Detailed Site Plan Departure from Design Standards New Carrollton Multifamily IV

DSP-22030
DDS-24001

SUBJECT: Detailed Site Plan DSP-22030
 Departure from Design Standards DDS-24001
 Type 2 Tree Conservation Plan TCP2-009-2024-01
 New Carrollton Multifamily IV

Figure 2: Site Plan of Parcels 11–15

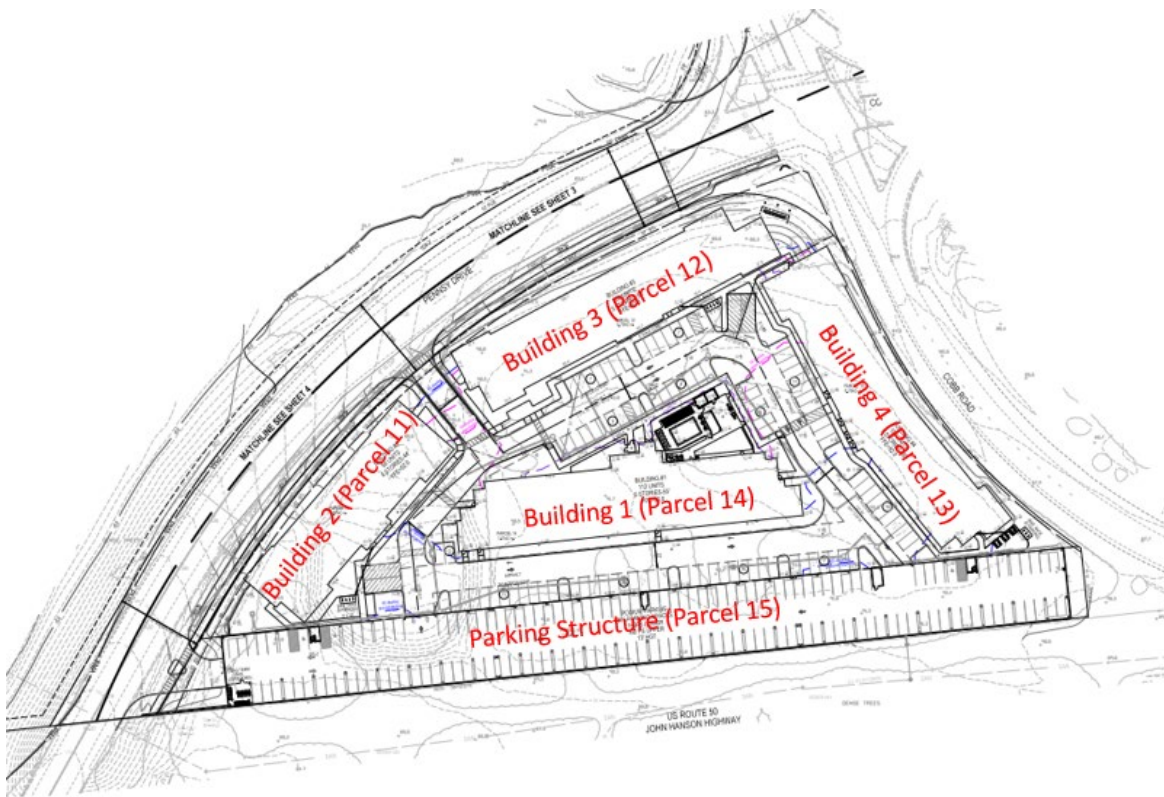
The site of Parcels 11–15 is bounded by Pennsy Drive, Cobb Road, and US 50. Two vehicular entry/exit points are located on Pennsy Drive. The western vehicular point is the entrance to the parking structure. The other vehicular point, located between Buildings 2 and 3, connects to a driveway that leads to the interior open space of the site. A bi-directional interior circulation loop surrounds Building 1, which not only provides vehicular access through the site, but also supports a secondary entrance to the parking structure. Improved sidewalks are shown along the Pennsy Drive Road frontage. Crosswalks are shown crossing the two vehicle access points. Buildings 2 and 3 front Pennsy Drive and Building 4 faces Cobb Road. Building 1 is located in the center of the site, while the parking structure lines the southern boundary abutting US 50.

Figure 4: Outdoor Recreational Facilities

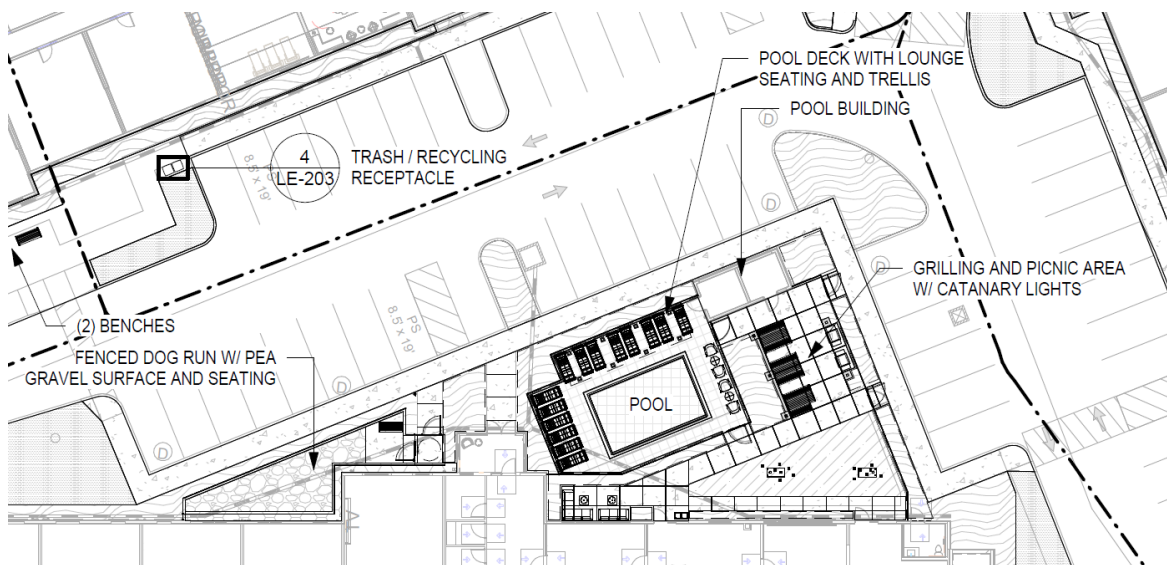
The submitted plan shows an outdoor recreational site located to the north of Building 1. However, a list of the proposed outdoor recreational facilities is not noted on the plan. A condition is included herein, requiring the applicant to itemize the quantity and value of outdoor recreational facilities and amenities, such as picnic tables with chairs, other types

of tables and chairs, grills, lounge chairs, and other amenities to be installed in the synthetic turf. The submitted plans show that the outdoor recreational site is being constrained by two bays of surface parking spaces immediately to its north and east. A condition is included herein, requiring the applicant to remove the parking spaces located to the north of Building 1 to enlarge the outdoor recreational site.

Figure 5: Indoor Recreational Facilities within Building 1

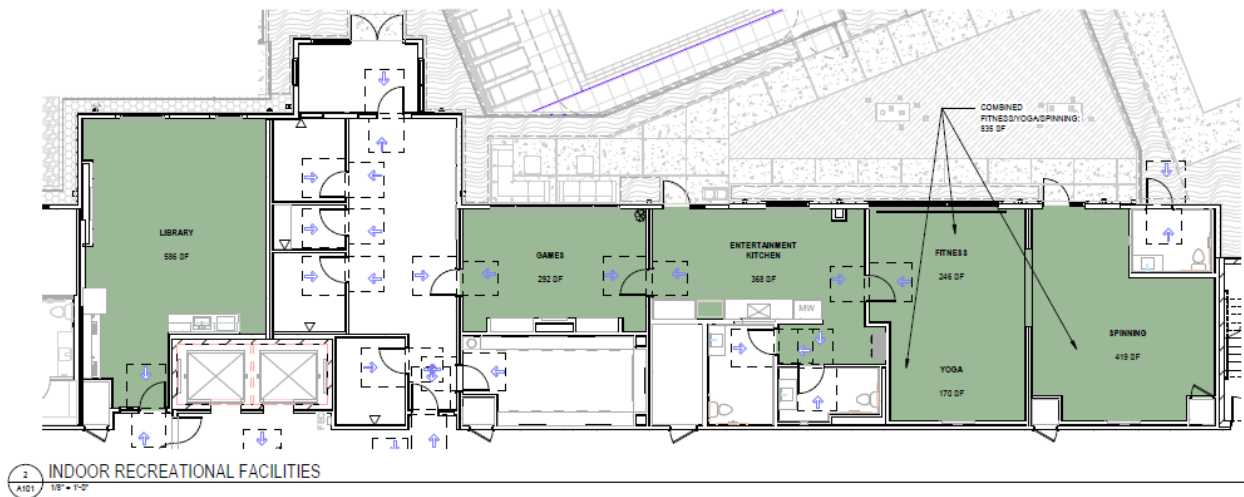
The submitted architectural floor plans also show that indoor recreational facilities are located within Buildings 1, 2, and 3. However, the facilities to be included in these rooms are not specified. A condition is included herein, requiring the applicant to provide large-scale, detailed floor plans showing the location of the proposed facilities within these rooms, and itemize the quantity and value of these amenities in the recreational facilities schedule on the coversheet. Another condition is included herein, requiring the applicant to add indoor recreational facilities to Building 4 and, if impossible, explain how future residents in Building 4 access indoor recreational facilities in other buildings. In addition to those indoor and outdoor recreational facilities, the applicant proposed a fenced dog run area, with a pet waste station. Given that a proposed library is proximate to the proposed dog run area, a condition is included herein, requiring the applicant to provide noise mitigation measurements to mitigate noise impacts on the library.
